TROUBLESHOOTER

LEADING TECHNICAL INFORMATION SUPPLIER AUTODATA SHARES FIXES TO THREE COMMON PROBLEMS FOUND IN MODERN MOTOR VEHICLES.

Audi A1 1.6 TDI

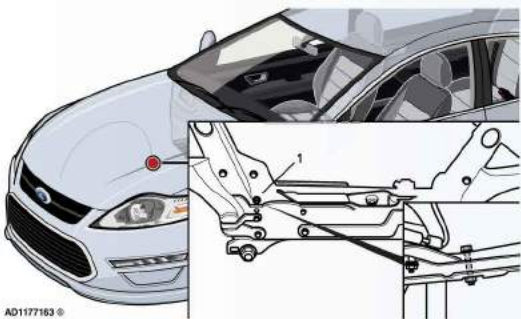
Question: We are having trouble finding the cause of a squeaking/rubbing noise from the engine compartment when pulling away or driving over uneven surfaces on a 2011 Audi A1 1.6 TDI. We have visually checked all of the steering and suspension components and checked that the engine mounting bolts are tight.

Answer: We are aware of this problem that is caused by excessive friction between the LH upper gearbox mounting rubber and mounting body. Access the gearbox mounting, slacken the mounting bolts and apply a small amount of silicon grease to the areas where rubber and metal are in contact (see Fig. 1). Retighten the gearbox mounting bolts and carry out a road test to confirm the noise is no longer present.

Ford Mondeo

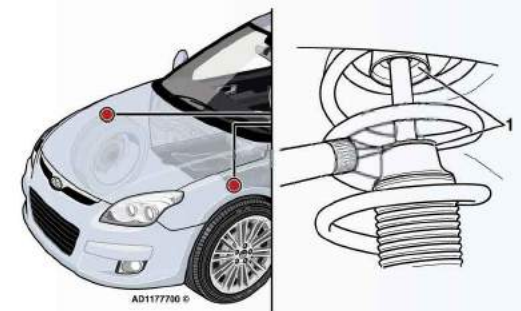
Question: We are having trouble finding the cause of a creaking noise from the front suspension when driving over uneven surfaces in a 2012 Ford Mondeo 2.2 TDCi. We have checked all the suspension components for wear and play. We have also made sure all the bolts for the front suspension and front subframe are tight and still the noise persists.

Answer: The problem you are describing affects all Mondeo, S-Max and Galaxy models from 2012-2013, excluding models fitted with the 2.0 EcoBoost engine. The cause of this creaking noise is excessive friction between the front subframe sections. Fit an additional nut and bolt available to the RH side of the front subframe to clamp the subframe sections together, then tighten the nut to 110Nm (see Fig. 1). Road test the vehicle, this should solve the problem.
